NEW YORK STATE DEPARTMENT OF ENVIRONMENTAL CONSERVATION

August 25, 2023

Re: Draft Pre-Design Investigation Work Plan
300 Commerce Drive
Site No.: C828158
Rochester (T), Monroe (C)

**Re: Draft Pre-Design Investigation Work Plan
300 Commerce Drive
Rochester, New York 14623
Site ID: C828158**

Figure 1

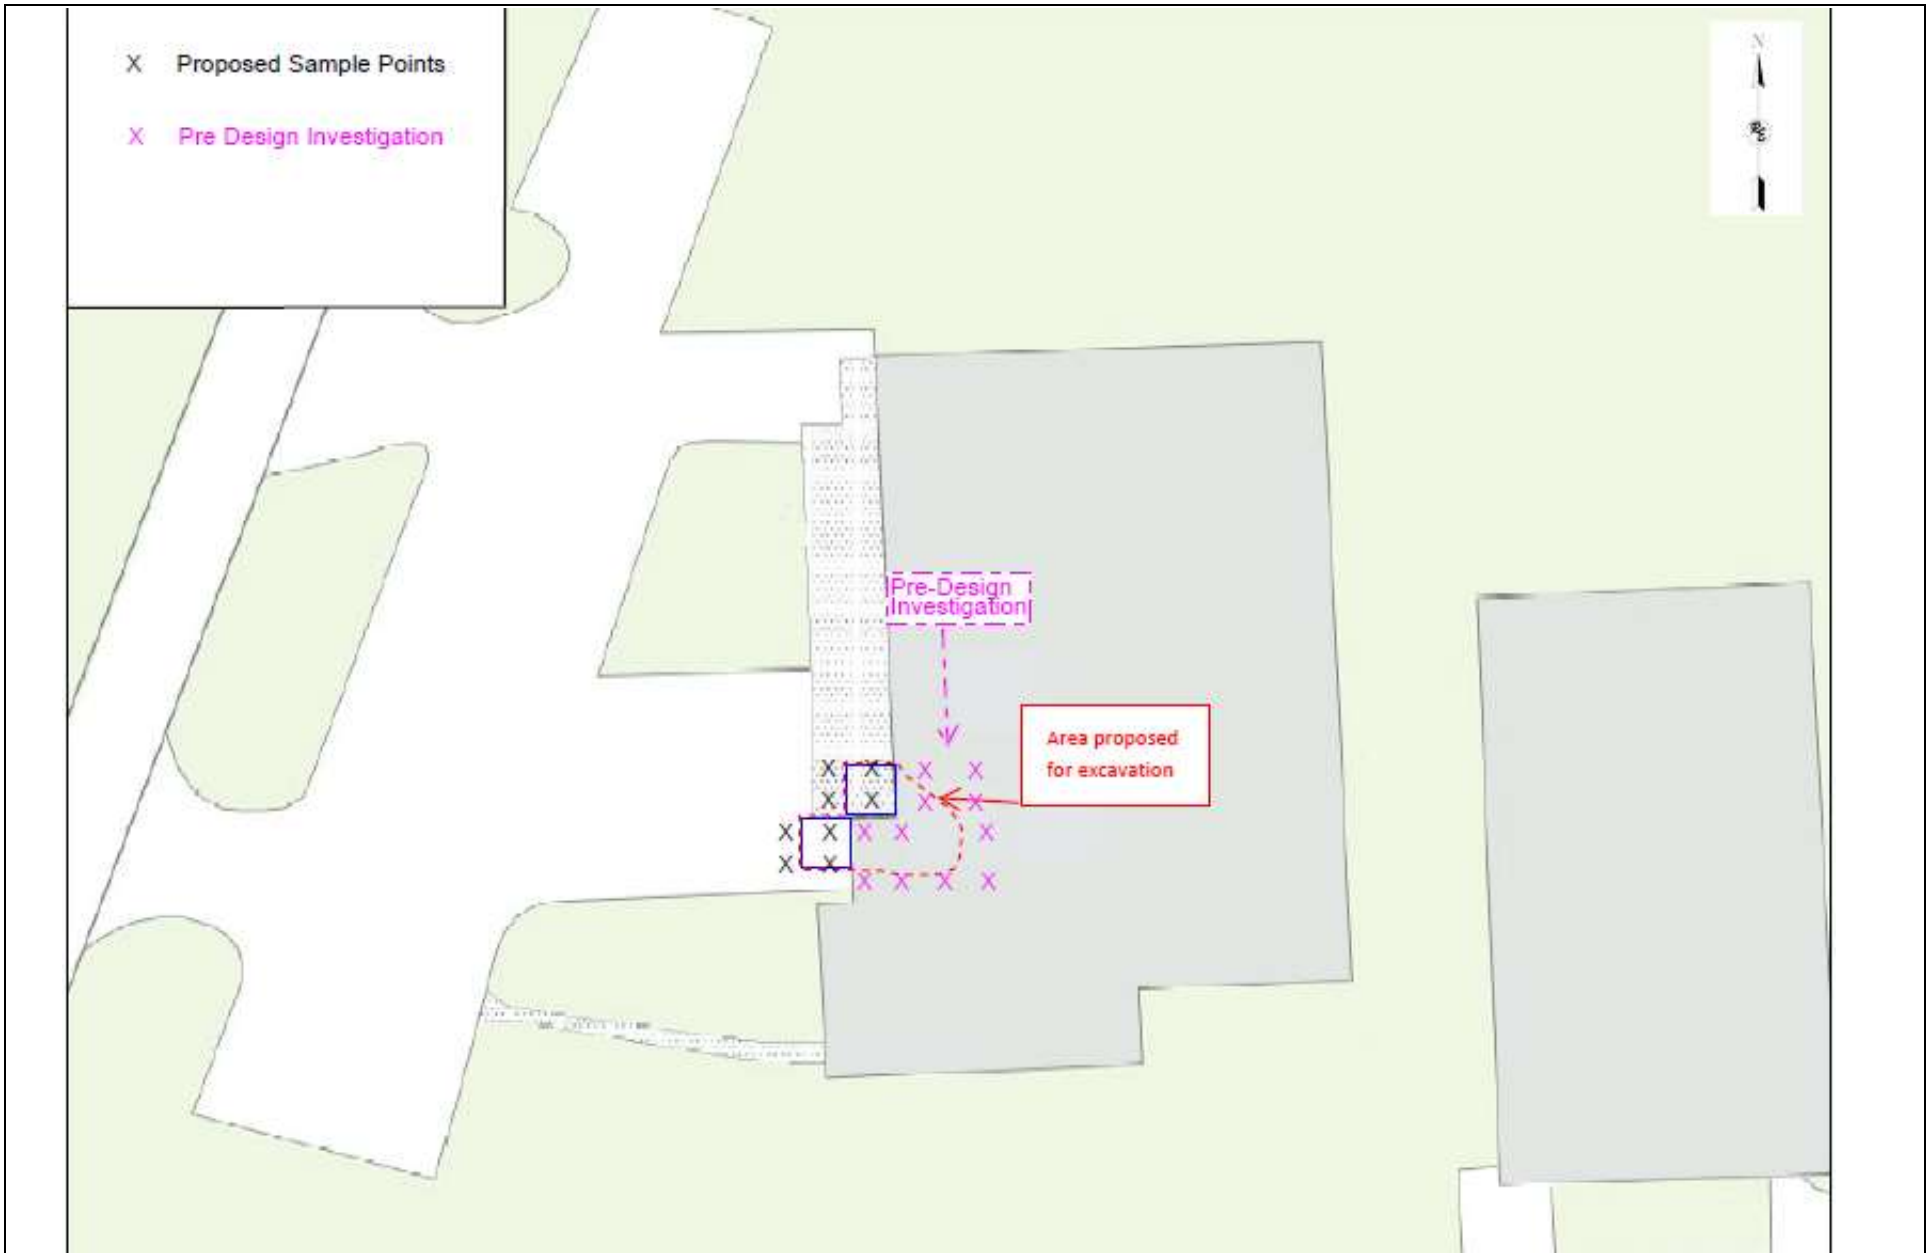
5. Prior to any ground intrusive activities at the Site, a utility survey will be completed and properly staked out.
6. The Department understands that at a minimum 20 Geo-probe borings will be installed to delineate the horizontal and vertical extent of contamination with respect to the protection of groundwater SCO's for PCE, TCE, and all associated daughter products. The Department also understands that at least 1 soil sample from each boring sleeve will be submitted for laboratory analysis at an ELAP certified laboratory. The Department also understands that headspace screening will be completed for each boring sleeve. Soil cores will be screened using a PID calibrated as per manufacture's specification as well as visual and olfactory impacts. Head space screening results will be recorded in the field logbook and readings will be provided in the letter report.
